**FINAL DRAINAGE REPORT
FOR
STERLING RANCH EAST FILING NO. 2
&
FOURSQUARE AT STERLING RANCH EAST
FILING NO. 1**

December 2022

See comments
provided with SF2237 -
Sterling Ranch East
Filing No 2

SF2236 &
SF2237

DETENTION BASIN OUTLET STRUCTURE DESIGN

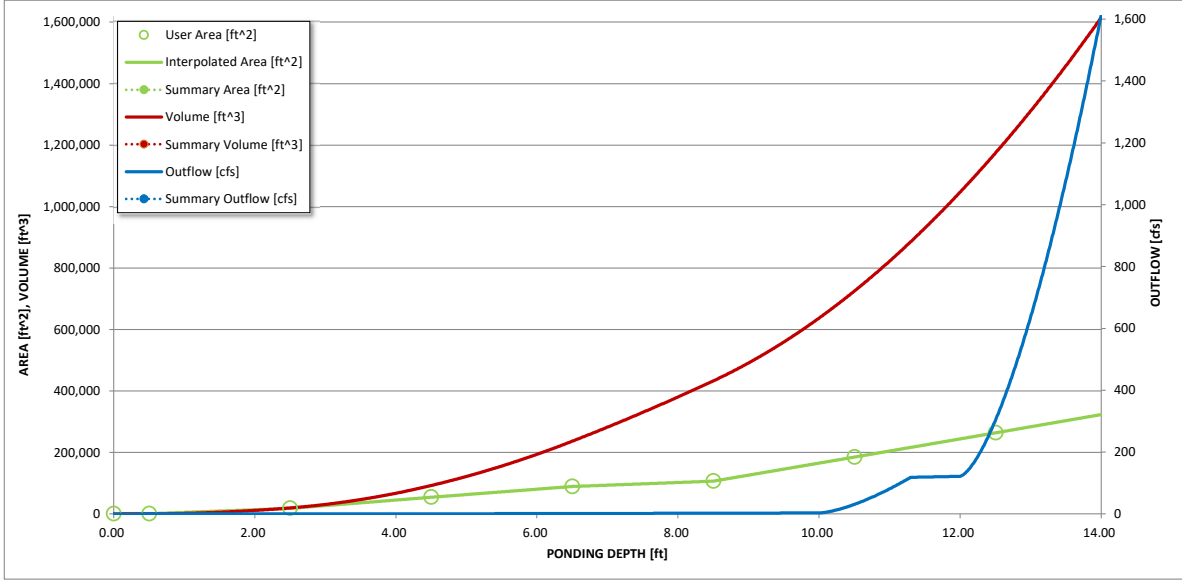
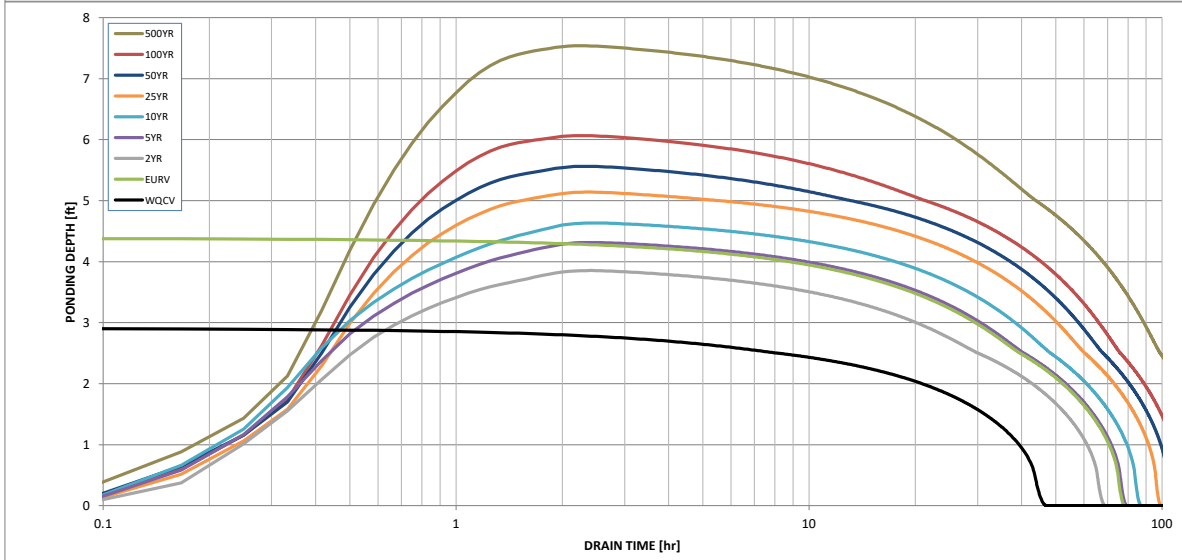
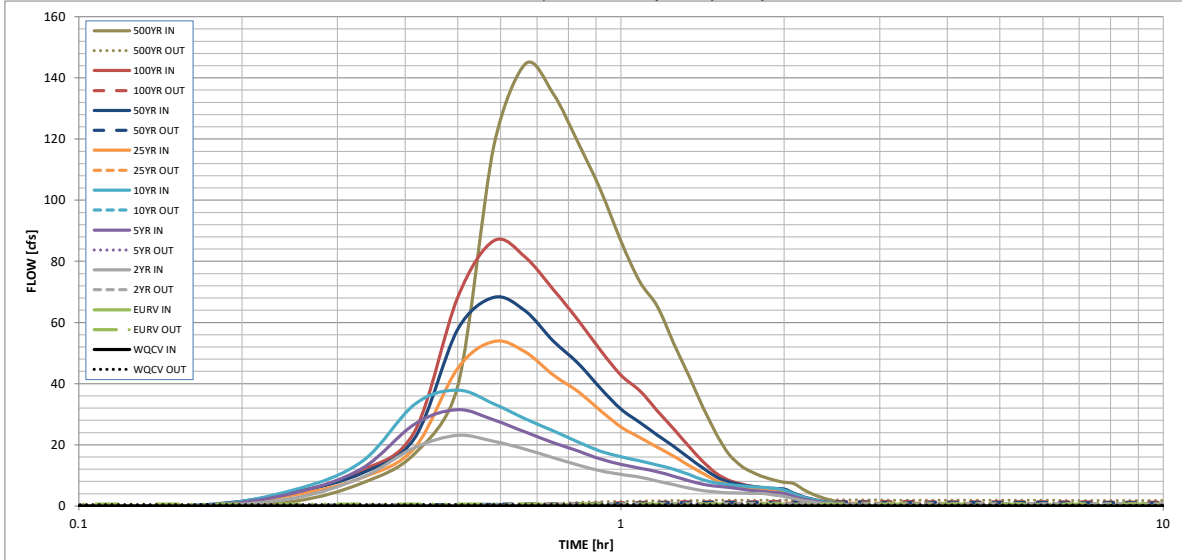
Rows highlighted above identify those that don't match what is shown on plans and details in CDs sheets 21 and 23

The plans and ultimate condition UD-detention spreadsheet show 12.5ft. I would think they wouldn't be different. Revise this to 12.5ft to match other calcs/plans.

DETENTION BASIN OUTLET STRUCTURE DESIGN

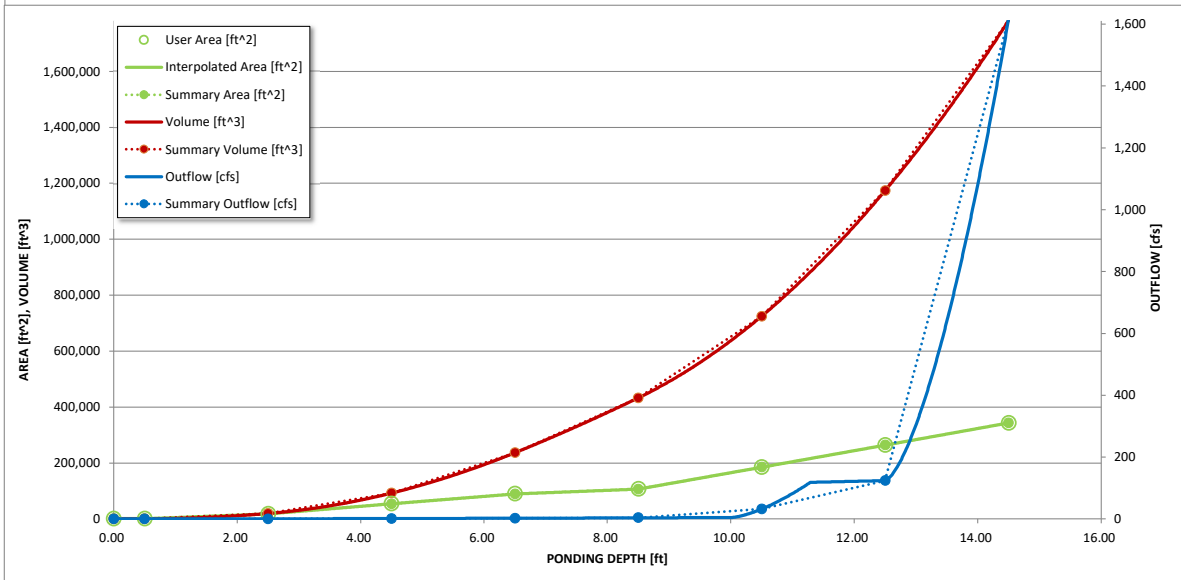
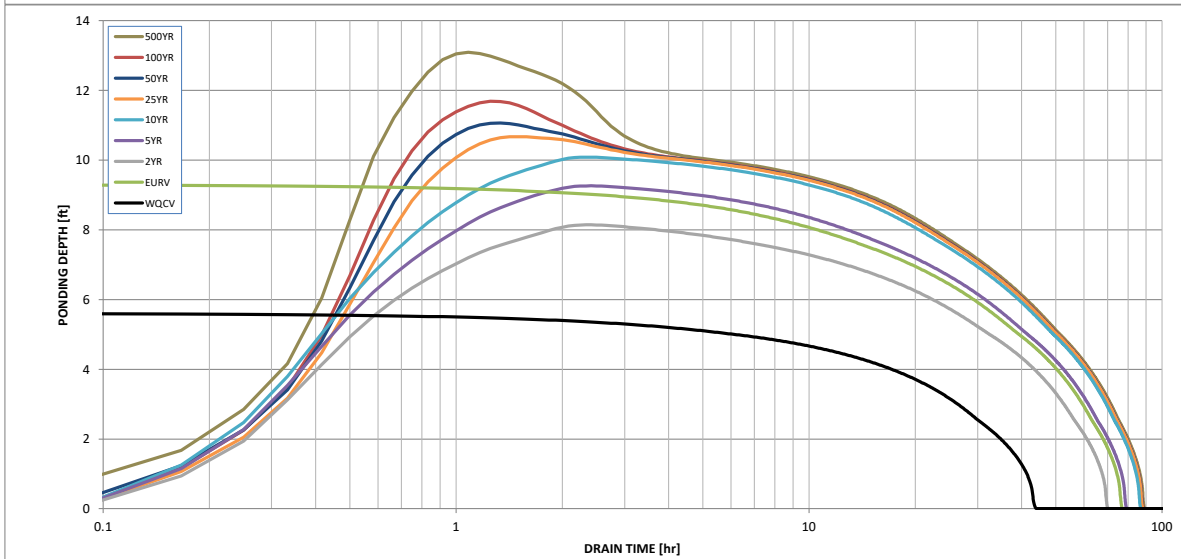
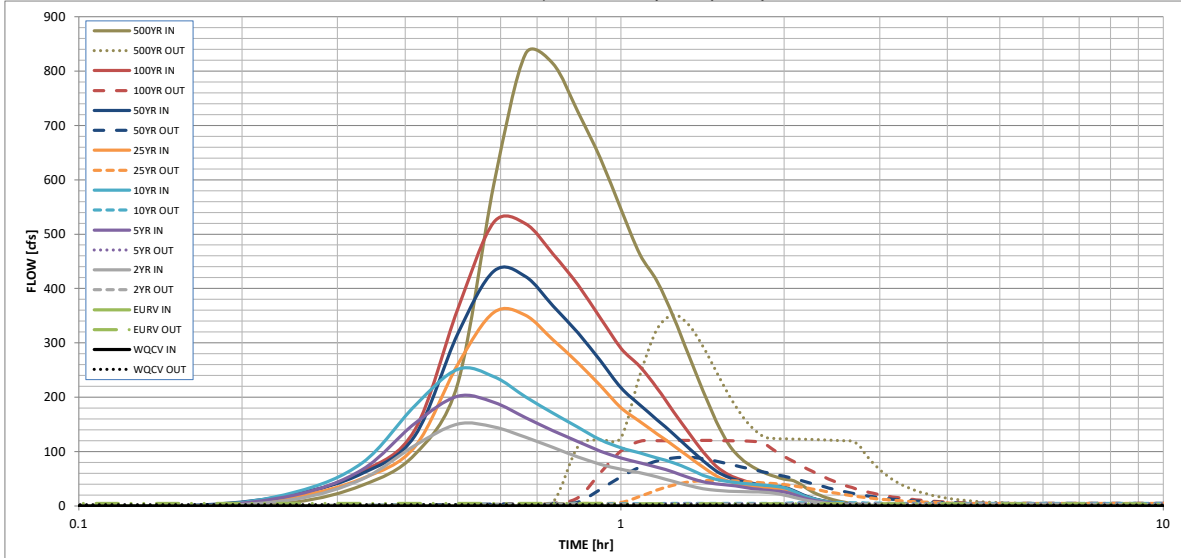
Rows highlighted below identify those that don't match what is shown on plans and details in CDs, sheets 21 and 23. But maybe since this is for the ultimate condition, the outlet structure is going to be modified later on to meet the calcs shown in this sheet? At least the orifice plate can be easily modified in the ultimate condition, but I wouldn't think that you'd want to dig up the outlet pipe and spillway when constructing the ultimate condition.

STERLING RANCH EAST PRELIMINARY PLAN NO. 1
Pond FSD-16 Tributary Area

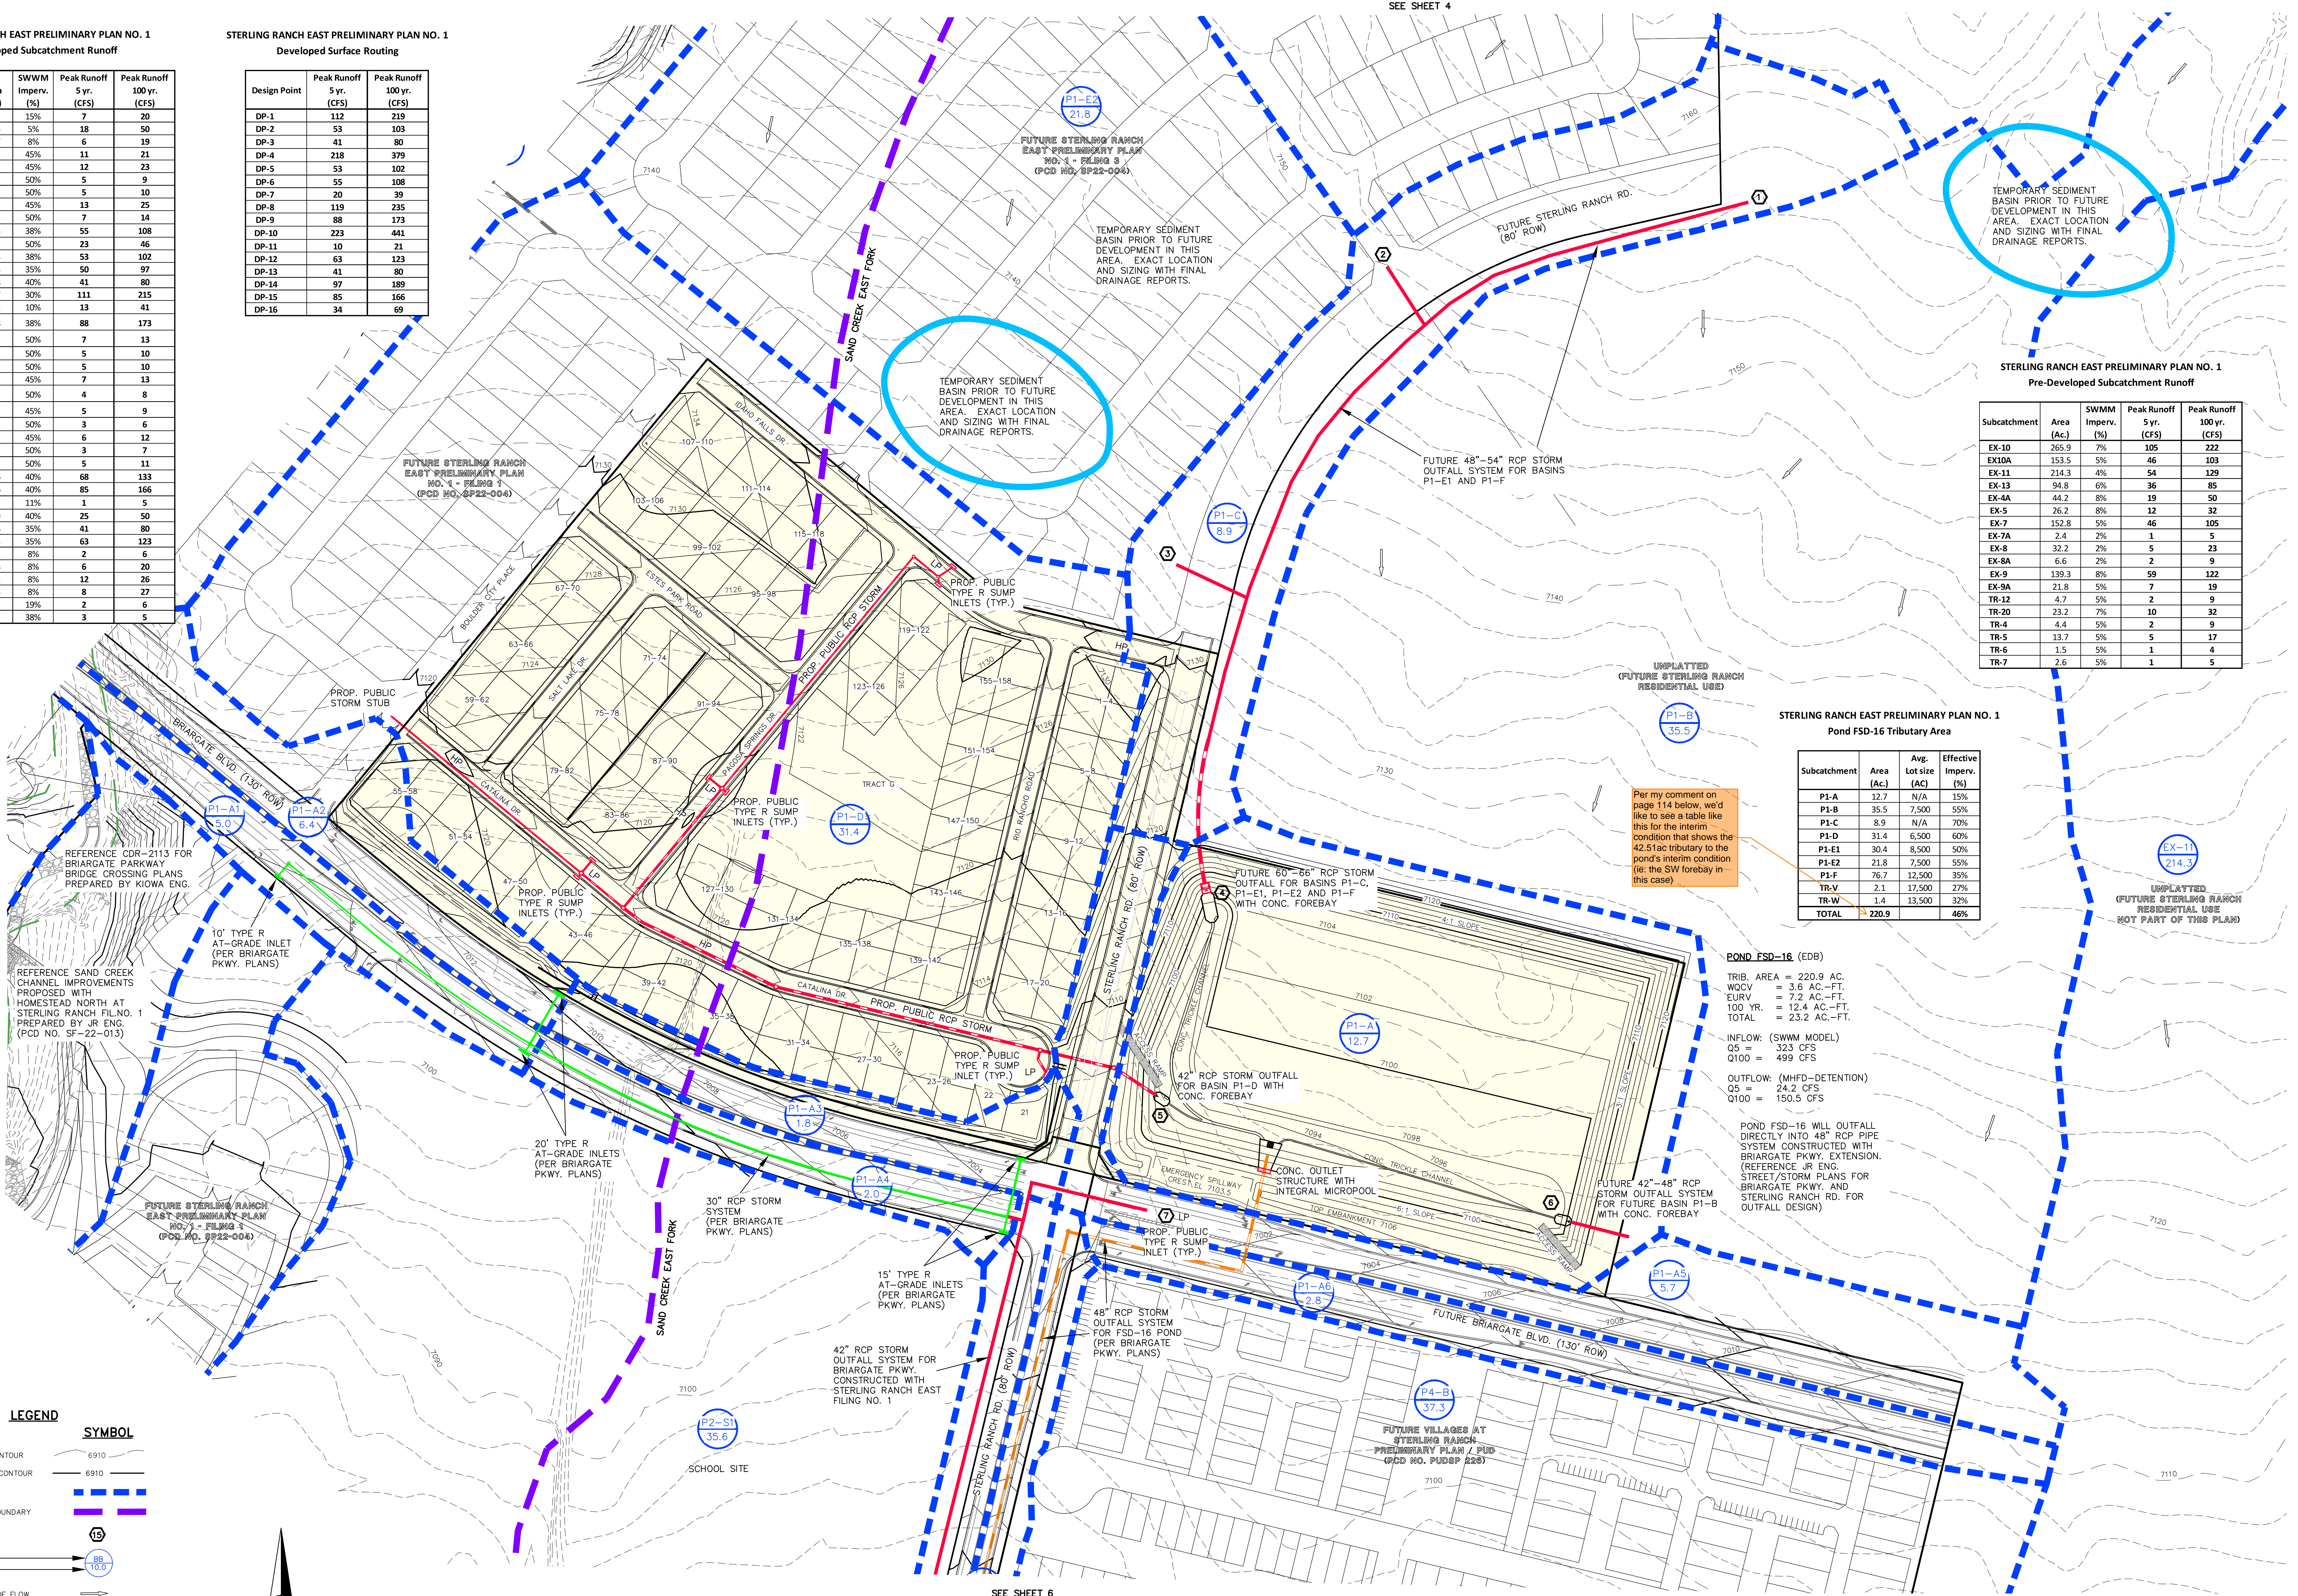
Per my comment on page 114 below, we'd like to see a table like this for the interim condition that shows the 42.51 ac tributary to the pond's interim condition (ie: the SW forebay in this case)

FOURSQUARE AT STERLING RANCH
PRELIMINARY PLAN / PUD
PRELIMINARY DRAINAGE REPORT
DEVELOPED DRAINAGE MAP

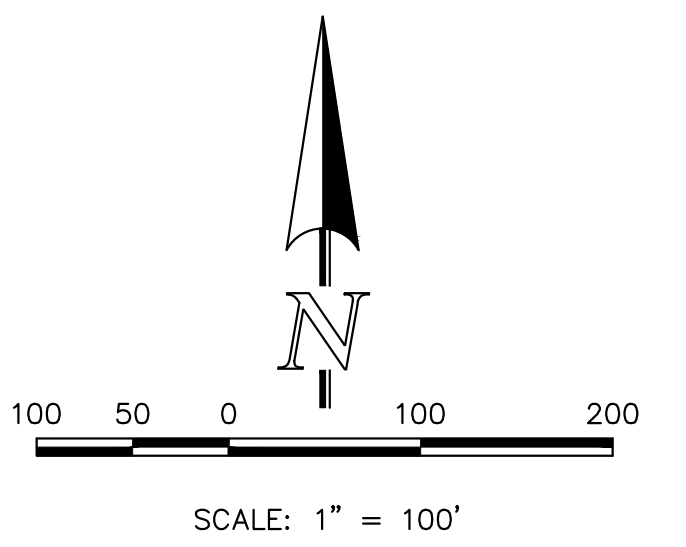
add yellow shaded area to Legend.

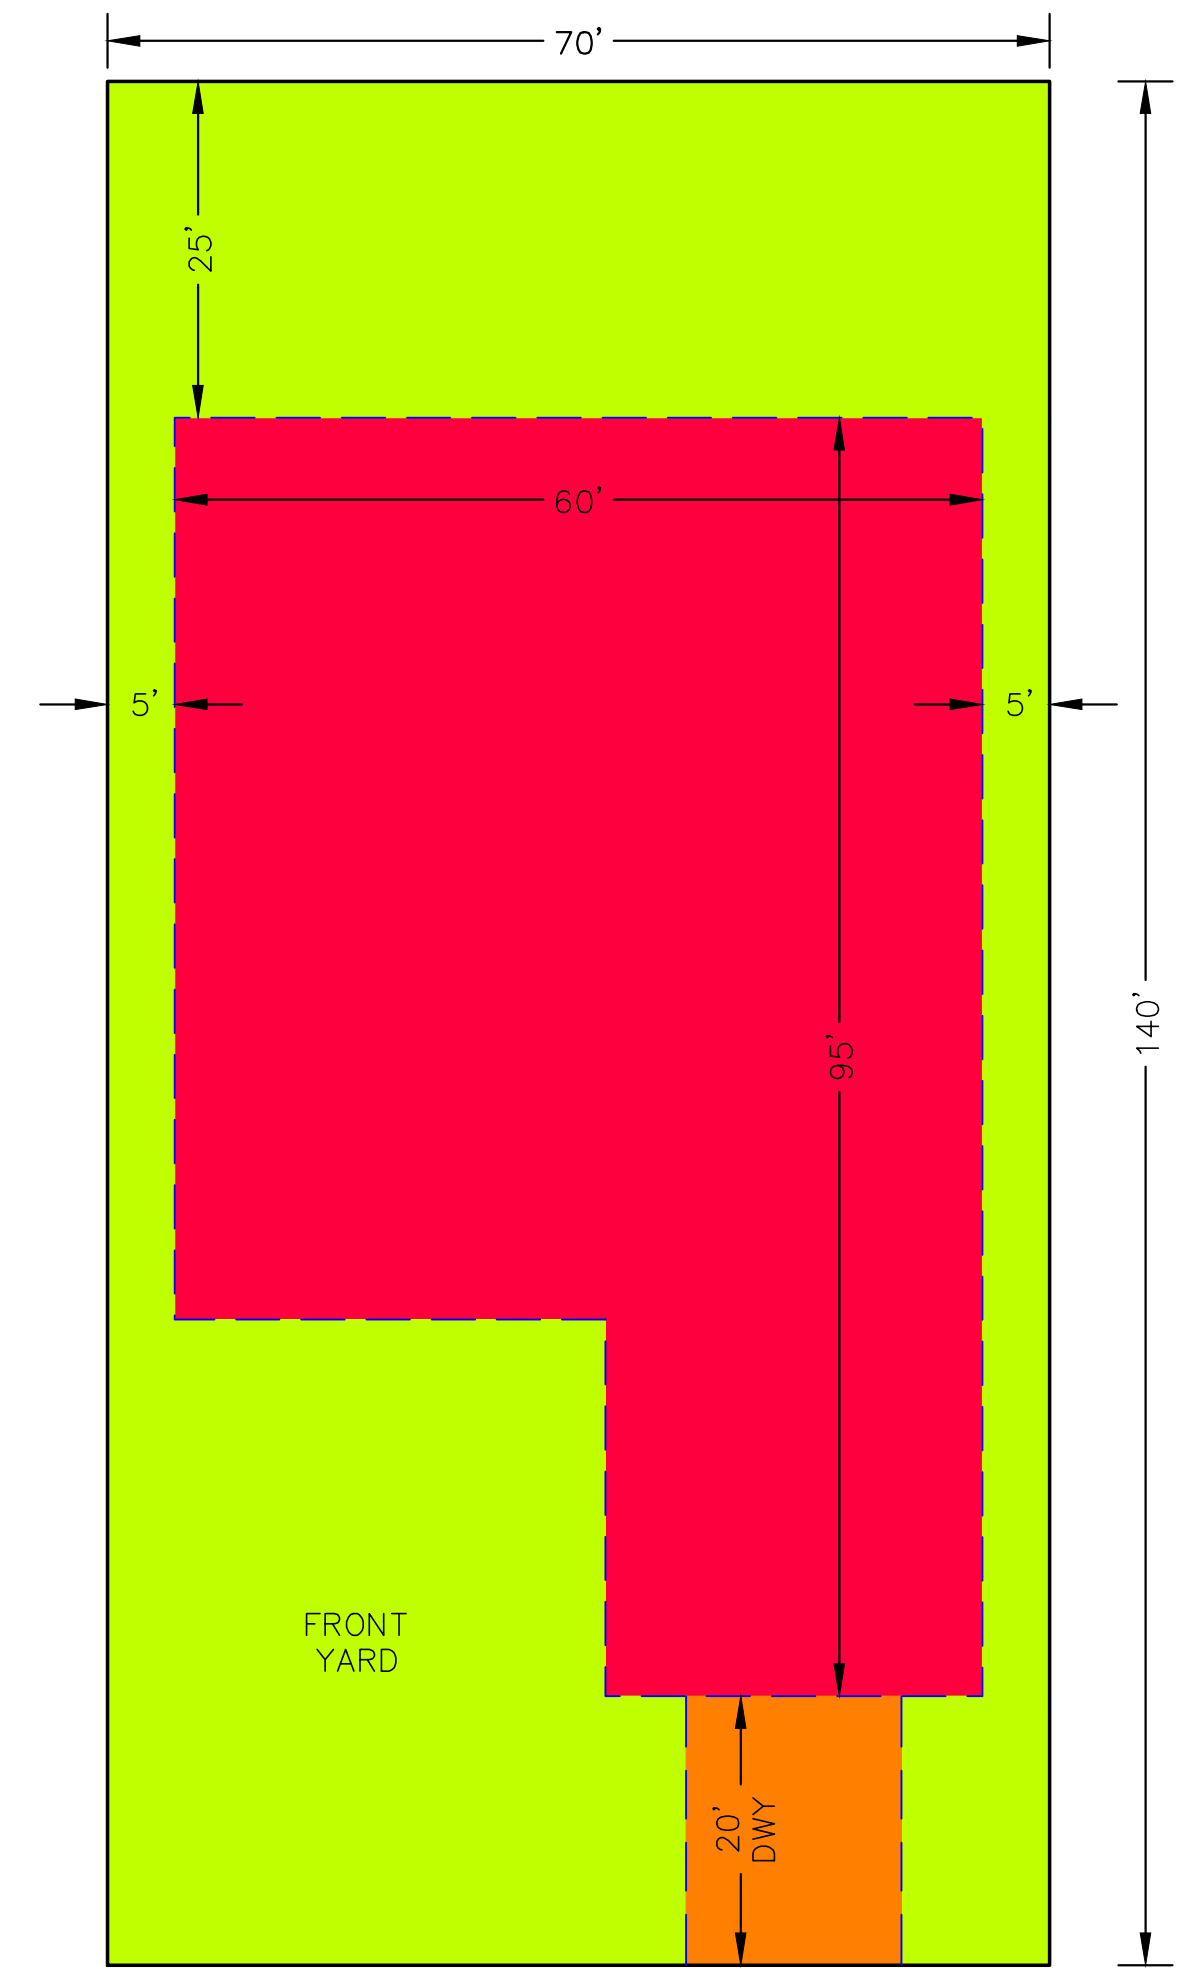
Runoff reduction shown in the back of these lots in WD summary map submitted with CDR204. RW no longer needed since it appears the grading has changed? What about for the disturbed to the NW that is sloped towards Sand Creek? I think on this map, that area should be shown as an SPA.

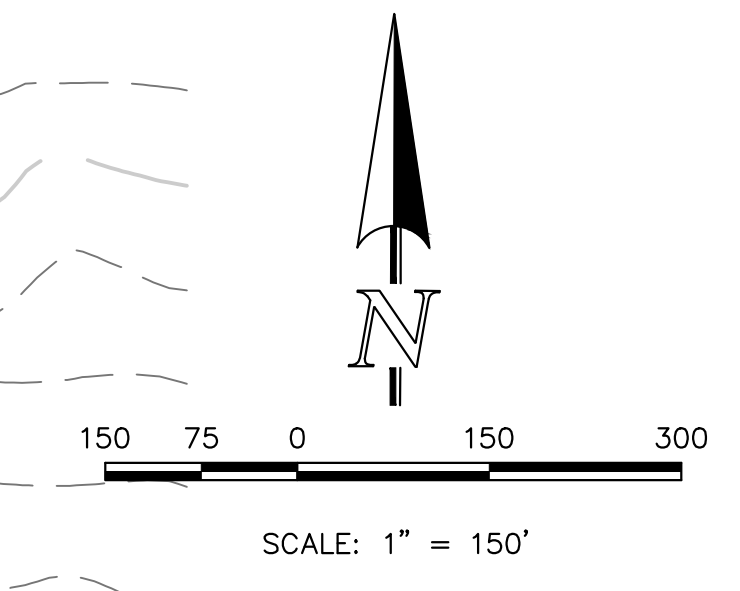
Please also include the "Water Quality Treatment Plan Map" that was included with the Drainage Report on SP224.
